Mt Pleasant LE- ADA Evaluation

Accessibility Evaluation

Report Date: 01/12/2024

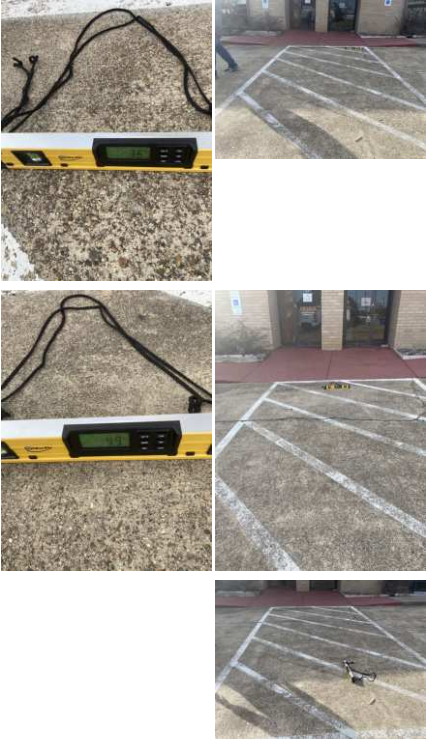
Finding Number	Area Description	Finding	As Built	Recommendation	Citation	Photos	Figure
1	Exterior of Property (Public): Parking Lot (2 Spaces) 1 Car 1 Van - Van Accessible Stall	The parking sign is mounted too low. Parking space identification signs shall include the International Symbol of Accessibility. Signs identifying van parking spaces shall contain the designation "van accessible." Signs shall be 60 inches minimum above the finish floor or ground surface measured to the bottom of the sign.	Van sign mounted less than 40"	https://www.access-board.gov/ada/#ada-502_6	2012 TAS Section: 502.6 2010 ADAS Section: 502.6		
2	Exterior of Property (Public): Parking Lot (2 Spaces) 1 Car 1 Van - Van Accessible Stall	The cross slopes (narrow dimension) and/or running slopes (long dimension) of the accessible stall exceeds 2%. The running slope and the cross slope in an accessible parking stall and the access aisle must not exceed 2%.	Accessible van stall exceeds cross and running slope requirements. There are a few locations where van parking stall cross slope more than 2%, no more than 5.9%. There are a few locations where van parking stall running slope more than 2%, no more than 3.7%. Locations can be found in additional photos.	https://www.access-board.gov/ada/#ada-502_4	2012 TAS Section: 502.4 2010 ADAS Section: 502.4

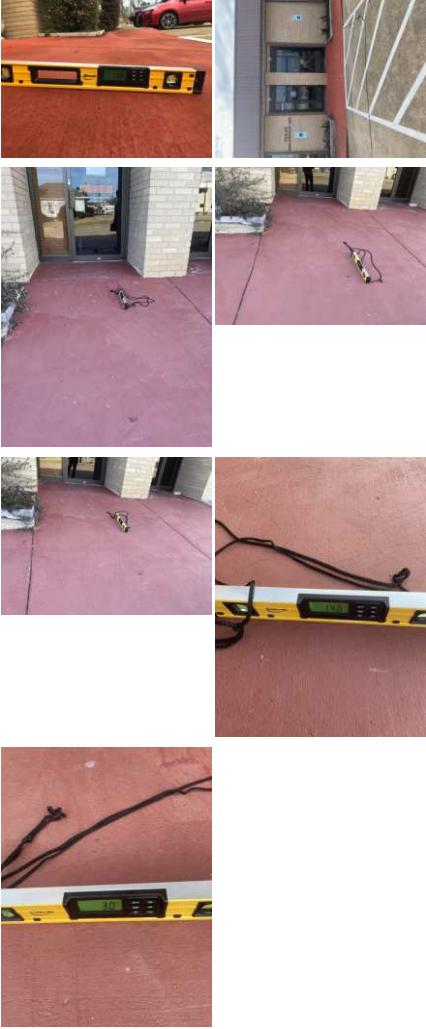
5	Exterior of Property (Public): Parking Lot (2 Spaces) 1 Car 1 Van - Car Accessible Stall	The accessible parking space and/or access aisle contains loose gravel and/or surface materials that do not provide for a stable, firm slip resistant surface. Parking spaces and access aisles serving them shall comply with floor or ground surface requirements. The ground surface shall be stable, firm, and slip resistant. Access aisles shall be at the same level as the parking spaces they serve. Changes in level, slopes exceeding 1:48, and detectable warnings shall not be permitted.	There is a large crack in accessible car stall decreasing access.	https://www.access-board.gov/ada/#ada-502_4 https://www.access-board.gov/ada/#ada-302_3	2012 TAS Section: 502.4 2010 ADAS Section: 502.4

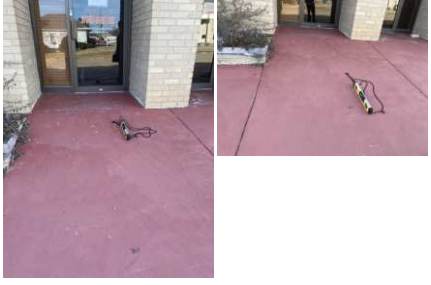
Finding Number	Area Description	Finding	As Built	Recommendation	Citation	Photos	Figure
6	Exterior of Property (Public): Parking Lot (2 Spaces) 1 Car 1 Van - Car Accessible Stall	The parking sign is mounted too low. Parking space identification signs shall include the International Symbol of Accessibility. Signs identifying van parking spaces shall contain the designation "van accessible." Signs shall be 60 inches minimum above the finish floor or ground surface measured to the bottom of the sign.	Accessible parking sign mounted less than 45"	https://www.access-board.gov/ada/#ada-502_6	2012 TAS Section: 502.6 2010 ADAS Section: 502.6		
7	Exterior of Property (Public): Parking Lot (2 Spaces) 1 Car 1 Van - Access Aisle (Shared)	The cross slopes (narrow dimension) and/or running slopes (long dimension) of the access aisle exceeds 2%. The running slope and the cross slope in an accessible parking stall and the access aisle must not exceed 2%.	Shared access Aisle has 2 locations of cross slope over 2% no more than 4.4% Shared access aisle has 2 location where running slope over 2% no more than 4.0% See additional photos for location of slope non compliance in shared access aisle. Running slope near bottom of aisle cross slope near top.	https://www.access-board.gov/ada/#ada-502_4	2012 TAS Section: 502.4 2010 ADAS Section: 502.4

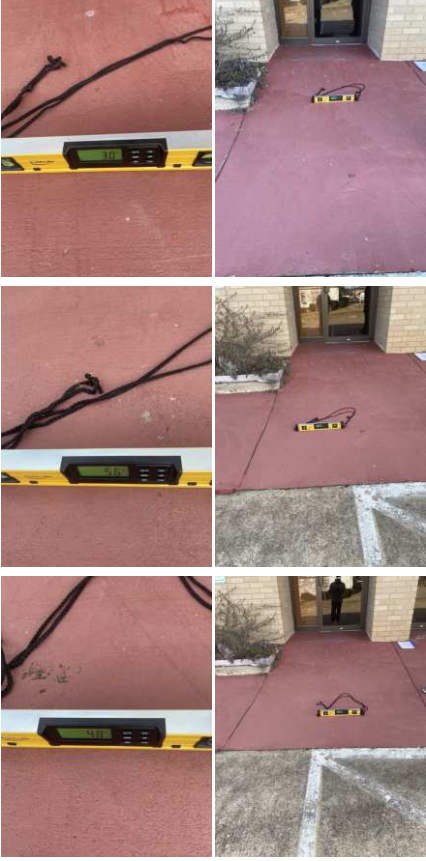
8	Exterior of Property (Public): Parking Lot (2 Spaces) 1 Car 1 Van - Access Aisle (Shared)	The access aisle contains loose gravel and/or surface materials that do not provide for a stable, firm slip resistant surface. Parking spaces and access aisles serving them shall comply with floor or ground surface requirements. The ground surface shall be stable, firm, and slip resistant. Access aisles shall be at the same level as the parking spaces they serve. Changes in level, slopes exceeding 1:48, and detectable warnings shall not be permitted.	There is a large crack in access aisle decreasing access.	https://www.access-board.gov/ada/#ada-502_4 https://www.access-board.gov/ada/#ada-302_3	2012 TAS Section: 502.4 2010 ADAS Section: 502.4

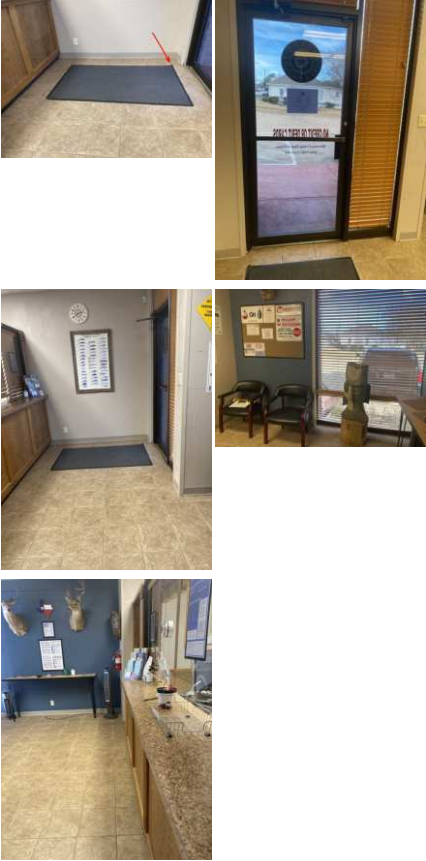
12	Exterior of Property (Public): Path of Travel to Building - Entrance Ramps (Non Curb Ramp)	The accessible route has running slopes greater than 5% and has not been constructed as a ramp (i.e. handrails, edge protection, etc.). Cross slopes are greater than 2% across the width of the walk. When the slope in the direction of travel of any walk exceeds 1 unit vertical in 20 units horizontal (5-percent slope), it must be constructed as a ramp. Surface cross slopes must not exceed 1 unit vertical in 48 units horizontal (2-percent slope).	The accessible route is not compliant due to running and cross slope compliance. There are several location on accessible route were running slope is higher than 8.33% no more than 15% There are a few locations on accessible route were cross slope is over 2% no more than 6% See	https://www.access-board.gov/ada/#ada-403_3	2012 TAS Section: 403.3 2010 ADAS Section: 403.3

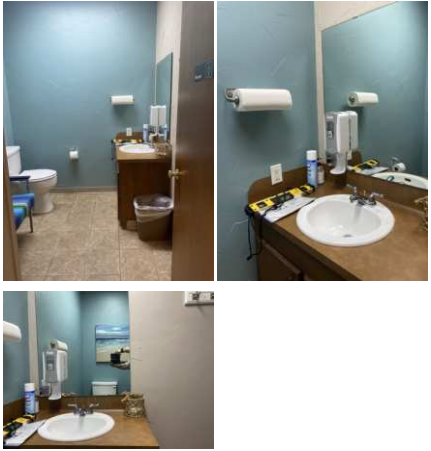
Finding Number	Area Description	Finding	As Built	Recommendation	Citation	Photos	Figure
		<p>spaces on the pull/push sides. The entry door encroach into the required clear floor space for fixtures. Grab bars are missing and/or incorrectly installed. Accessories, such as toilet seat covers, paper towel holders, garbage cans, hand dryers, and mirrors are either too high or without clear floor space or both. The restroom contain floor level changes greater than a 1/2 inch of the floor drains and is slope (XX) - (XX), the shower is too small and missing numerous accessible elements.</p>	<p>enough accessible space - There is no access to lavatory or accessories - Flush handle on wrong side - Toilet paper dispenser not in correct location - Door hardware not complaint</p>
